Addendum No.1, RFQF 14-96

To: Prospective bidders RFQF 14-96, Landscape Architecture Services, Marshall St. Park

Re: Questions & Answers

Addendum No. 1 to RFQF 14-96

Draft ADA Report on Marshall St. Park

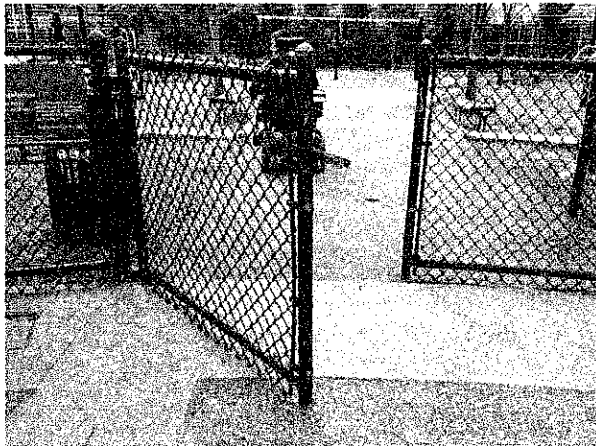
- Pedestrian Crosswalks & Curb Ramps: accessible
- Sidewalks: accessible
- Gates: inaccessible

- Walkways: water pooling areas, uneven surface

- Playgrounds: provided, not on accessible route

- Benches: 11 provided, 8 not on accessible route, all lack clear space along side
- Picnic tables: Not on accessible route, on uneven ground surface

This playground has a small paved area near the entrance. The rest of playground is dirt covered with wood-chippings, including the locations of the play structure and the majority of the benches. The surfaces under some of the benches and picnic tables have eroded significantly causing uneven ground levels and benches to be two or more feet above the surface.
